SUBJECT: CYCLE 10 RELOAD ANALYSIS AND LICENSE AMENDMENT (TAC 67605)

Re: Quad Cities Nuclear Power Station, Unit 2

AMENDMENT TO FACILITY OPERATING LICENSE

Amendment No. 104  
License No. DPR-30

FIGURE 2.1-3  
(SCHEMATIC)

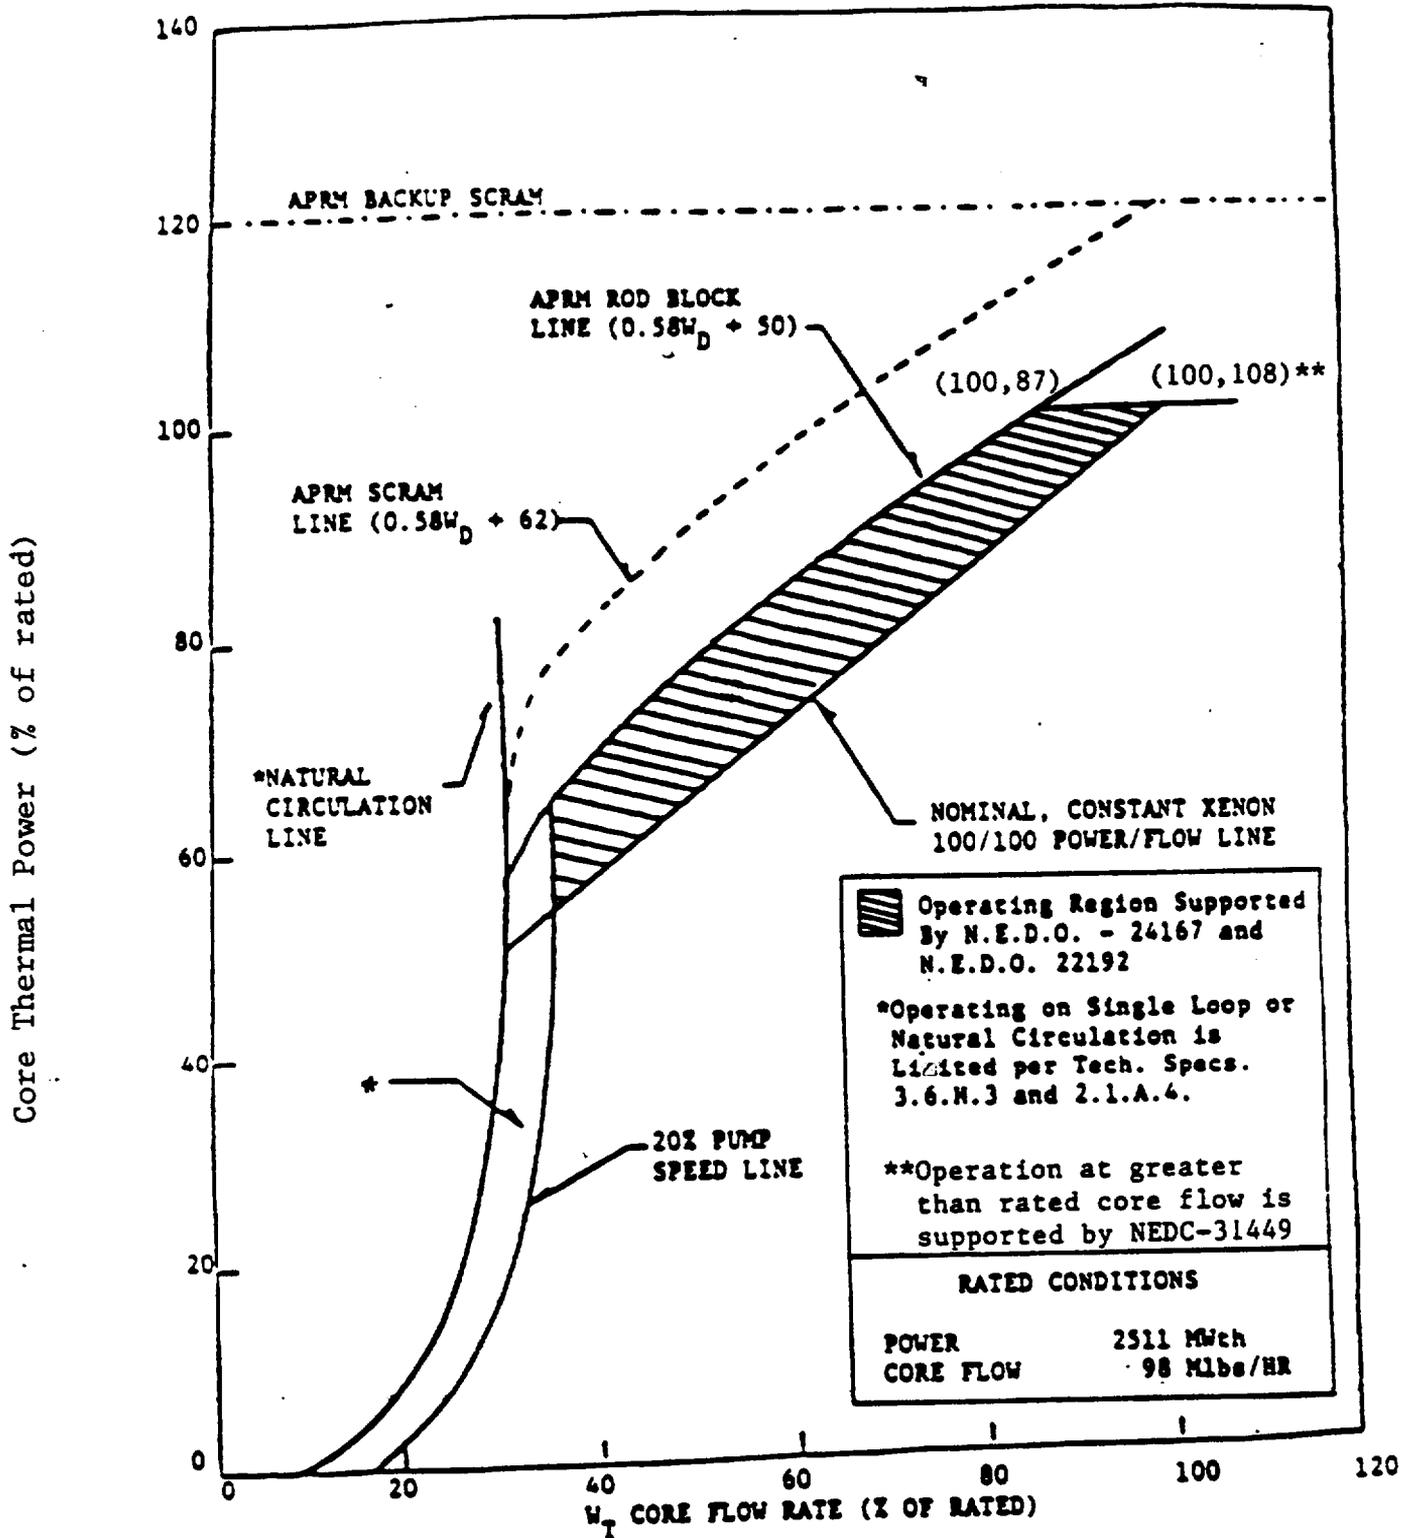
5. Figure 2.1-3

Add operating region as defined by the increased core flow analysis which is evaluated in Section 2.6 of this SER. This is acceptable.

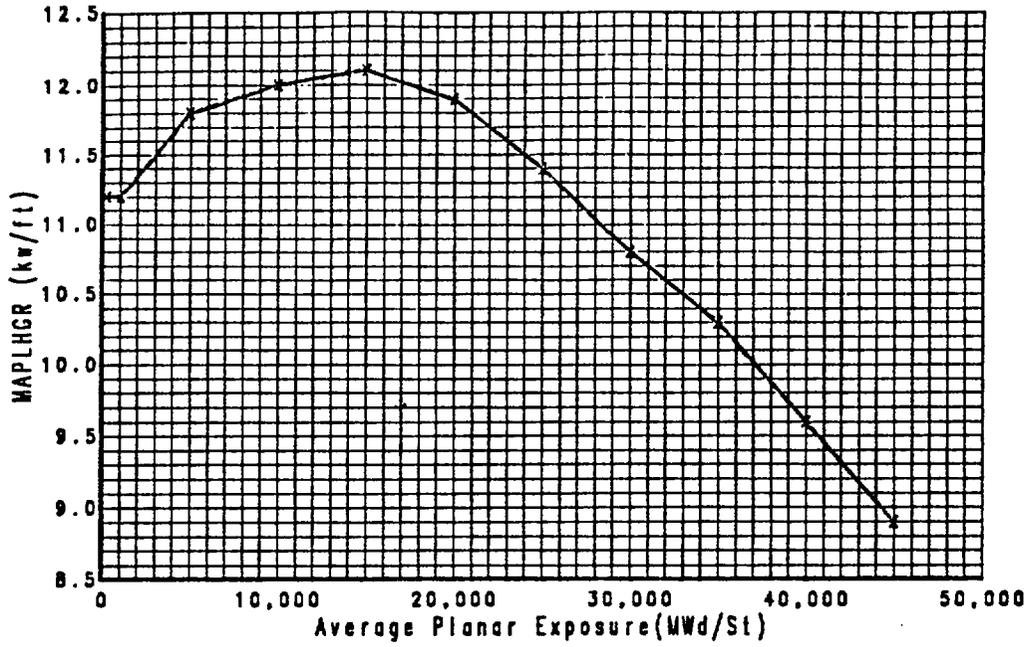
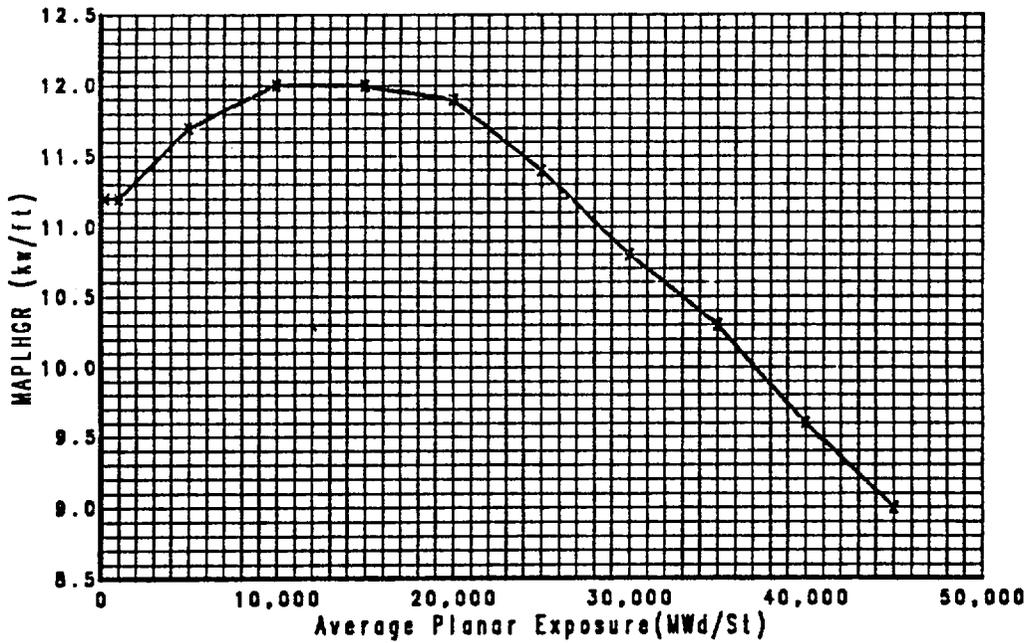
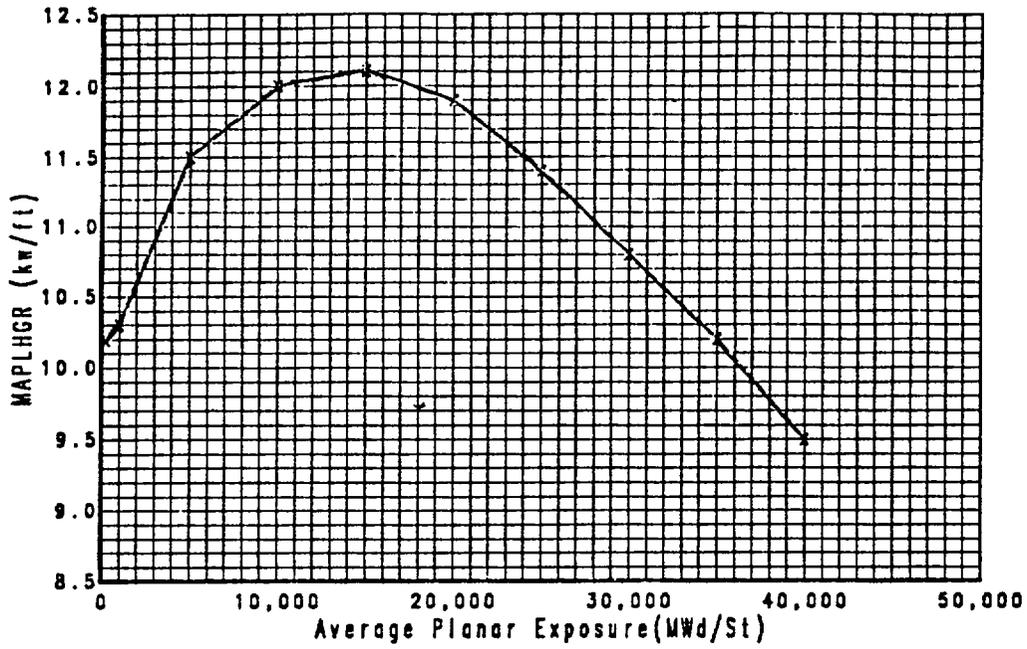
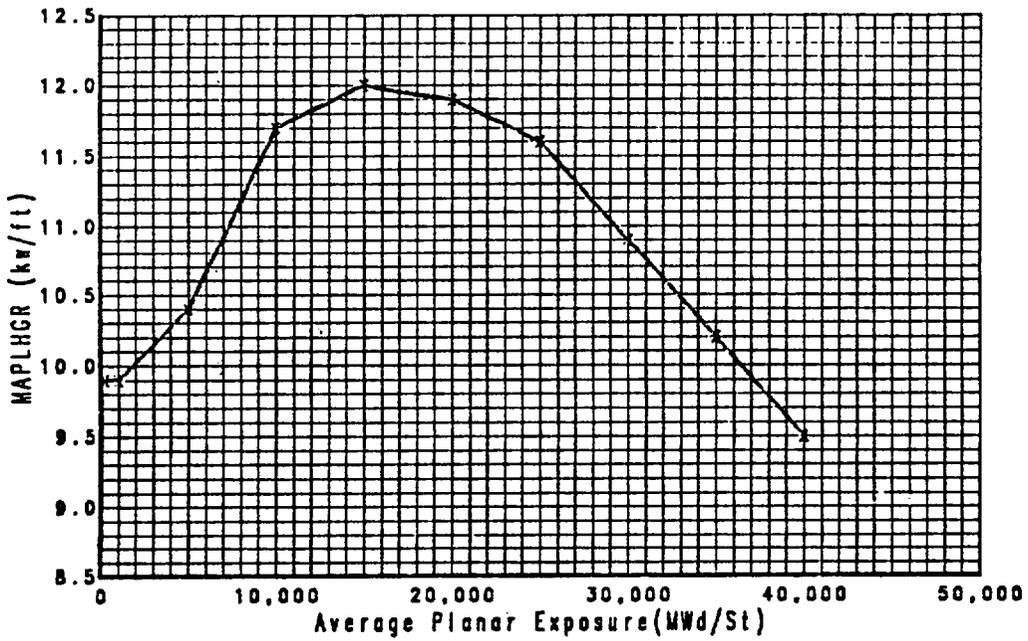
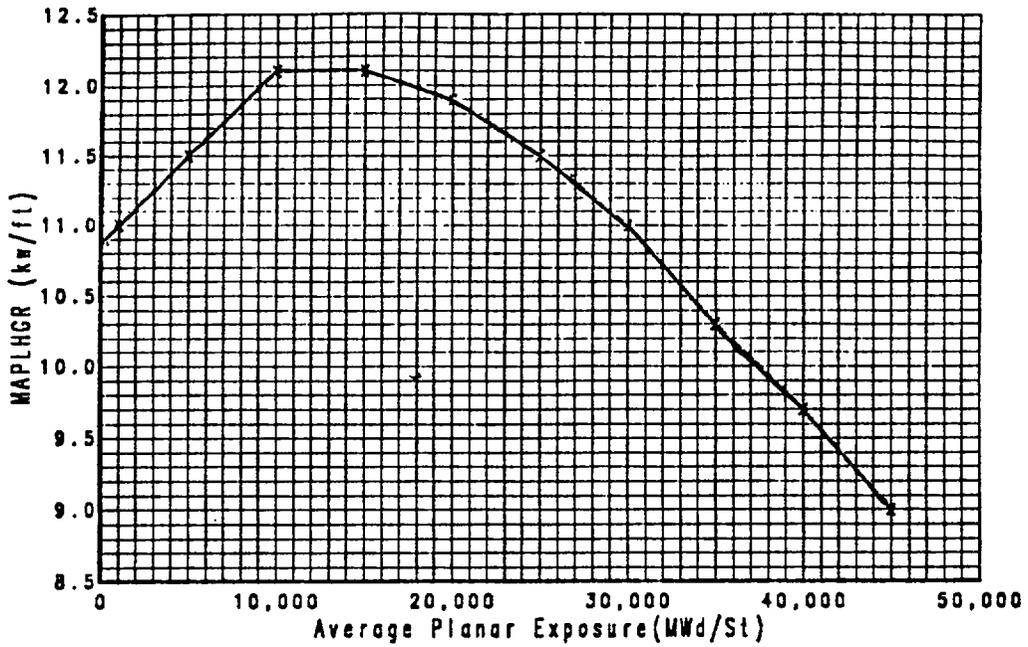
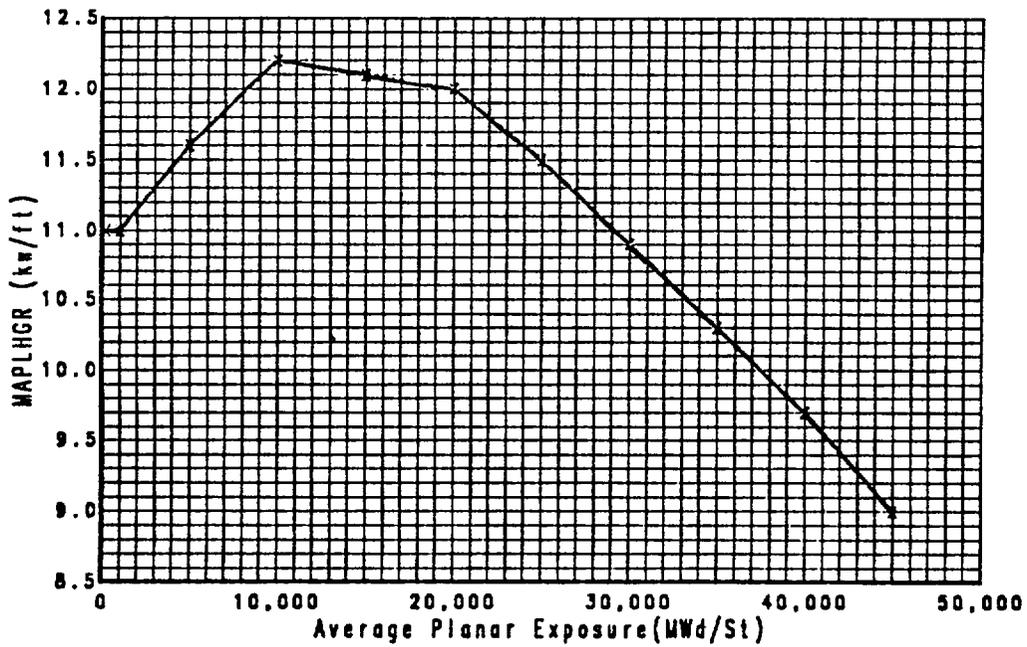
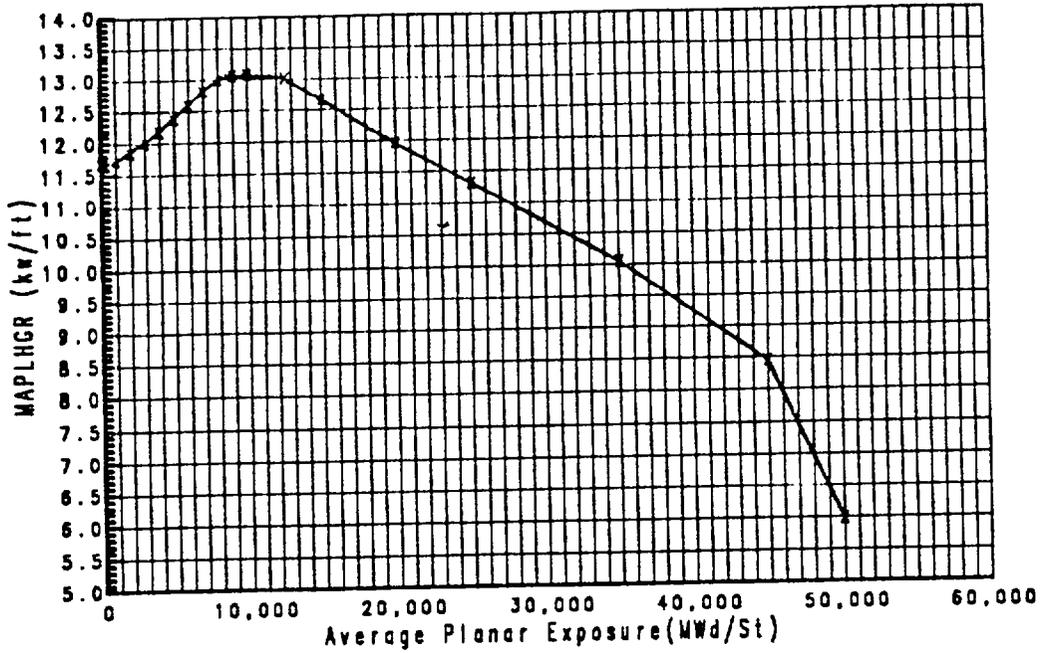
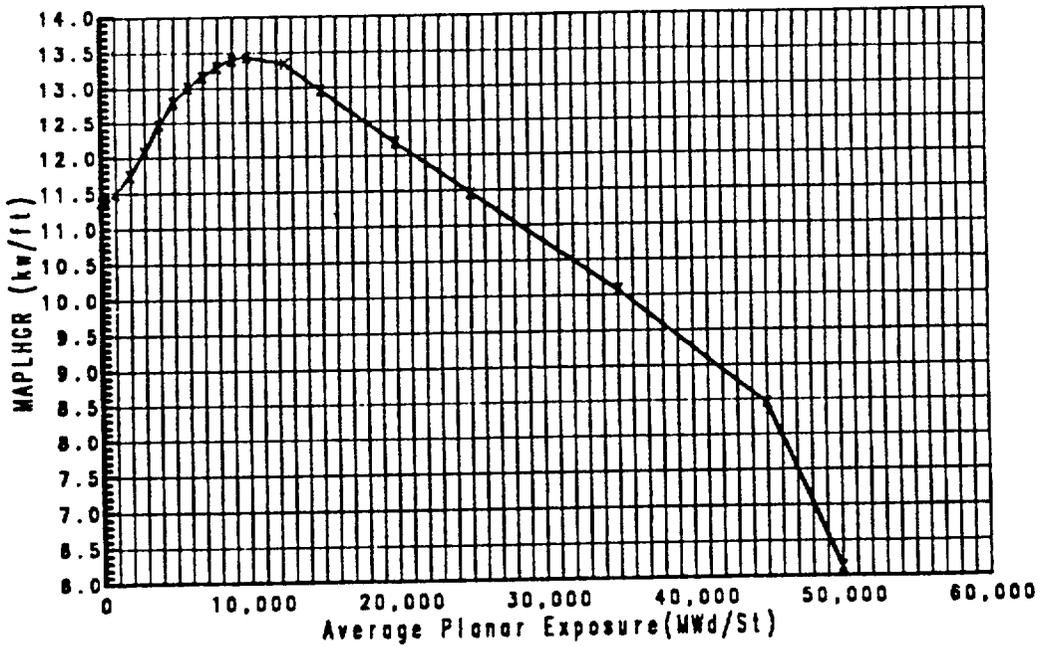
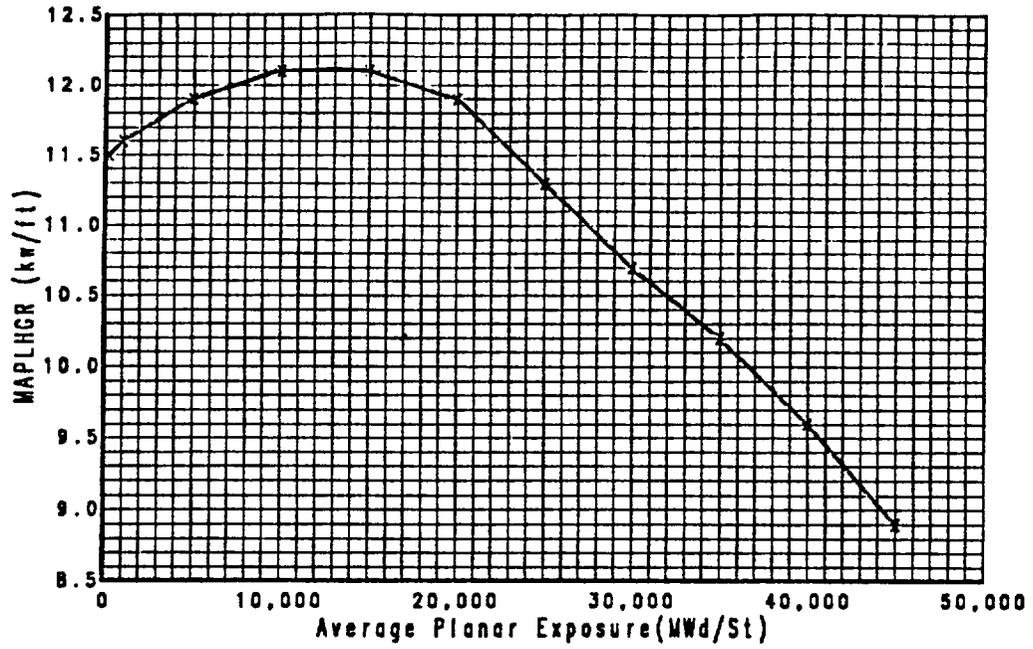
10. Figure 3.5-1

Add new MAPLHGR curves for new fuel types BD300C and BD316A and delete MAPLHGR curves for fuel types no longer in use. This is acceptable.

FIGURE 3.5-2

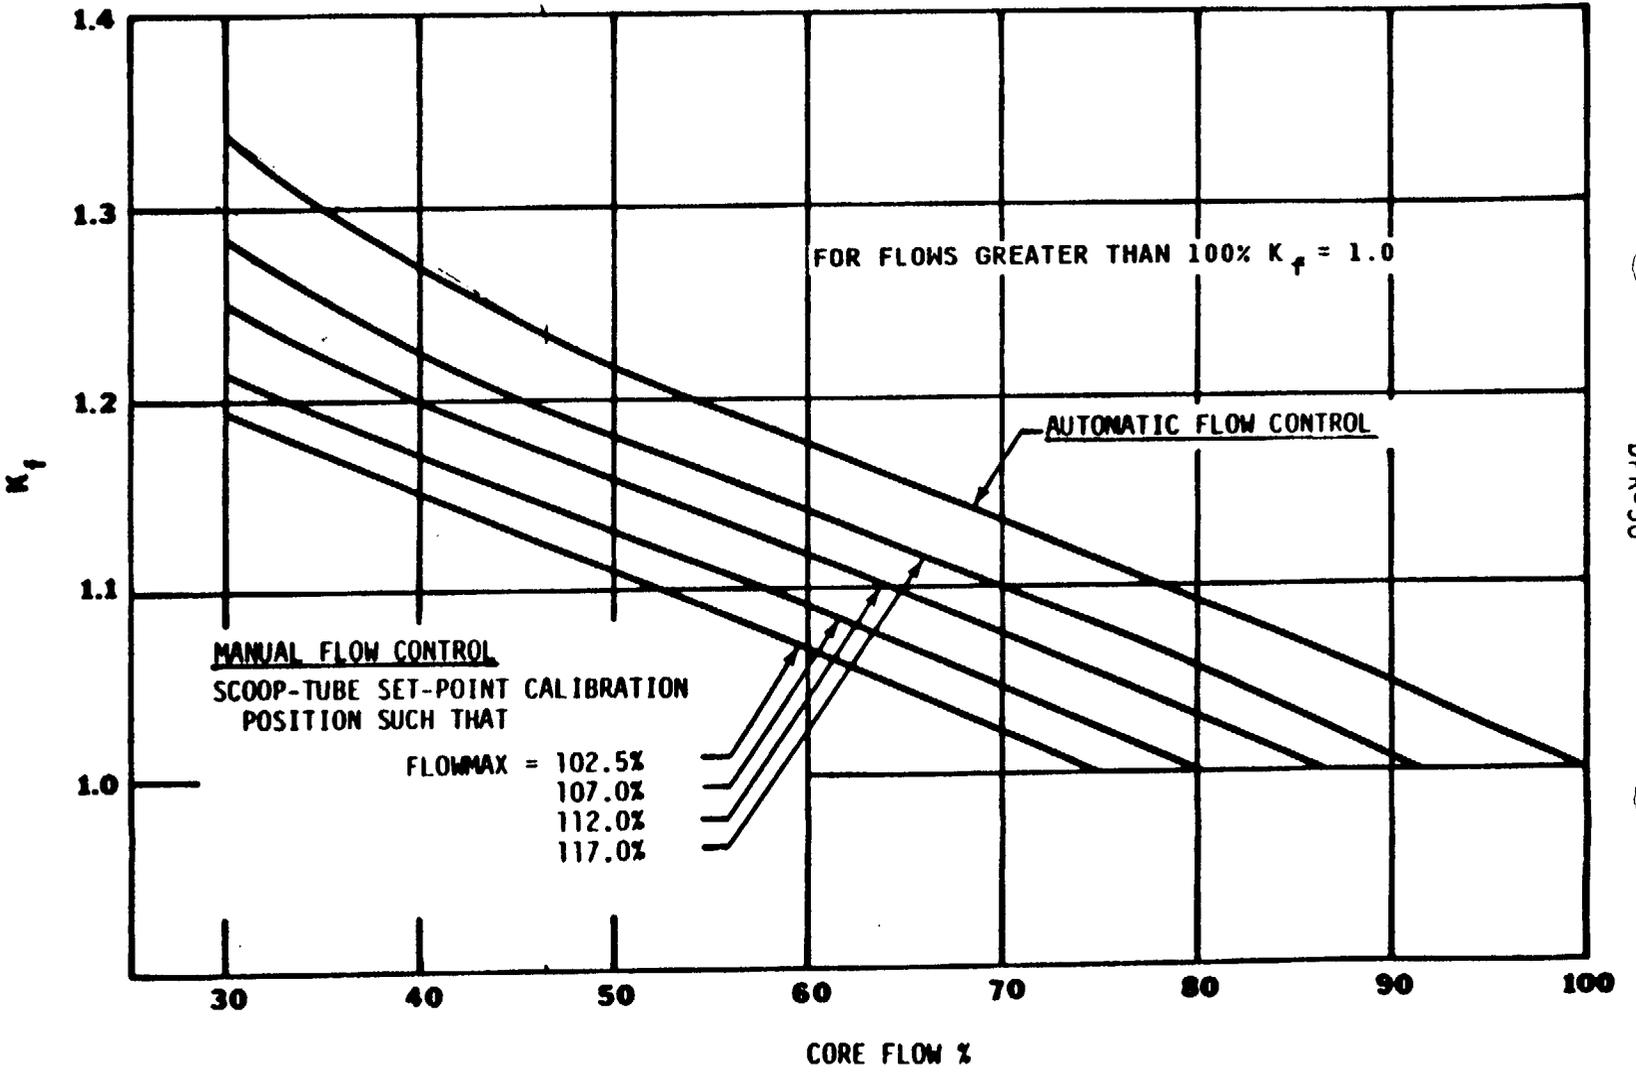
11. Figure 3.5-2  
Add the statement "For flows greater than 100%,  $K_f = 1.0$ " to the figure to address the operating region defined by the ICF analysis. This is acceptable.
12. TS 3.6.H.3 on page 3.6/4.6-5a and TS Bases on page 3.6/4.6-13a  
Delete the MAPLHGR reduction factor during single loop operation based on the SAFER/GESTR-LOCA analysis. This is acceptable since an approved method was used. Revise RBM upscale limit due to new RBM setpoint. Reduce the allowed duration of unrestricted SLO to 12 hours.
